# Albuquerque Bernalillo County Water Utility Authority

## Development Facilitation Team (DFT) – Review Comments

**Project No: PR-2022-007986 Date: 4/2/2025      Agenda Item: #8      Zone Atlas Page: F-10**

**Request: Subdivide the existing lot into 6 lots served by a new extension of Cleghorn Rd**

**\*See Exhibit below**

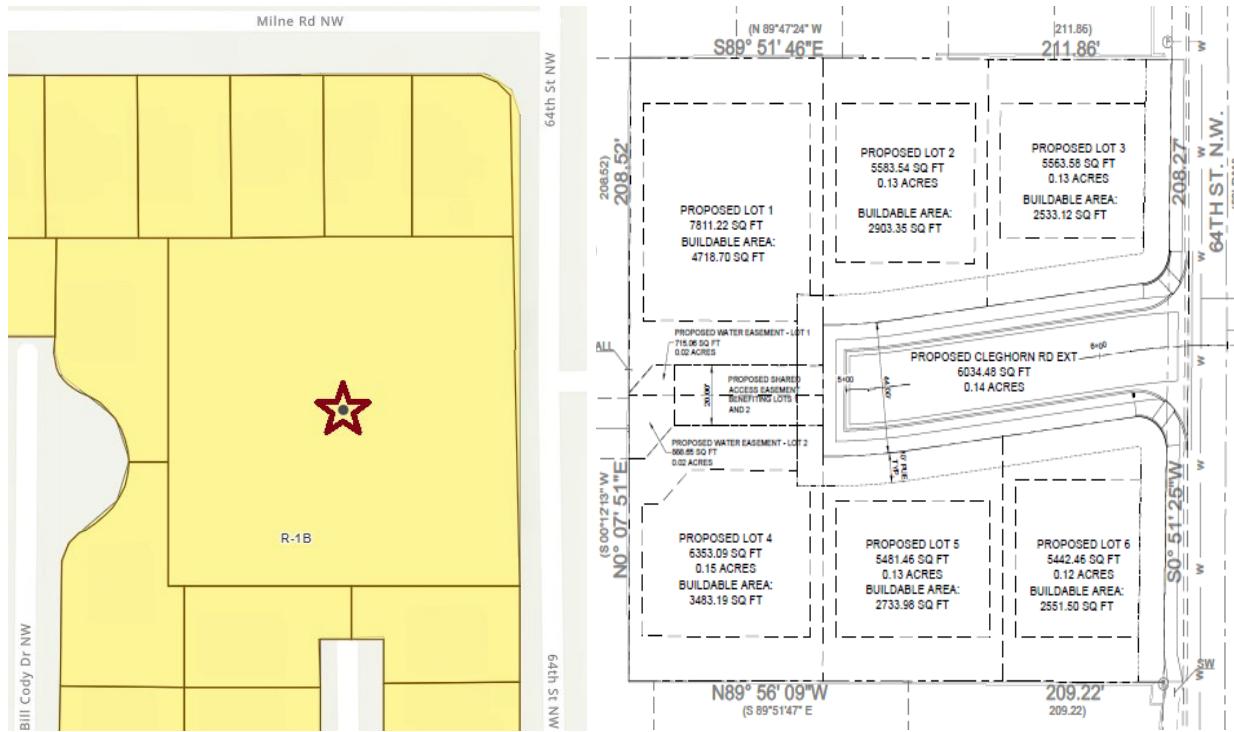
- This is a request for a Sketch Plat review to subdivide an unplattoned lot in the Town of Abq Grant into six separate lots, each approximately 0.13 acres in size. The re-plat includes a proposed 20-foot-wide public water easement and a proposed 10-foot wide Public Utility Easement (PUE) around the proposed right-of-way (ROW).
